DRAWING	NO. TITLE		REV. C	DART AEROSPACE USA	A, INC D.E.O. NO.	SHEET NO.	SCALE
D2731	MOUNTIN	NG LUG		ENGINEERING ORDE	D2731-C-1	SHEET 1 OF 1	NTS
DRAWN	P	CHECKED	SC	MFG. APPR.	APPROVED	DE APPR.	,
DATE	11.05.02	DATE 1/	1.05.09	DATE //.05.09	DATE 11.05.09	DATE 11.05.09

PURPOSE

ADD D2731-xRG OPTION

<u>D2731-1RG MOUNTING LUG (SHOWN)</u> D2731-3RG/-5RG/-7RG MOUNTING LUGS (SIMILAR)

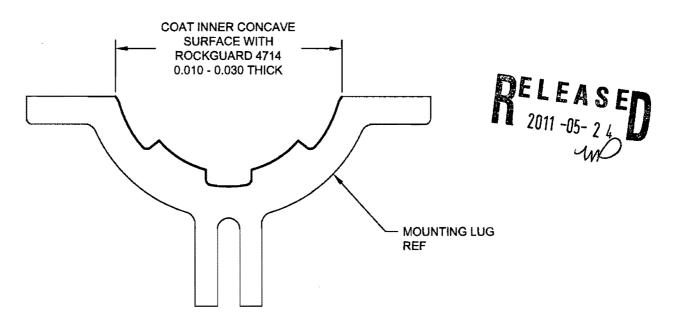
D2731-xRG MOUNTING LUGS ARE INDENTICAL TO D2731-x MOUNTING LUGS, HOWEVER AFTER FINISH, COAT INNER CONCAVE SURFACE WITH "PLUS ONE ROCKGUARD 4714" AS SHOWN BELOW.
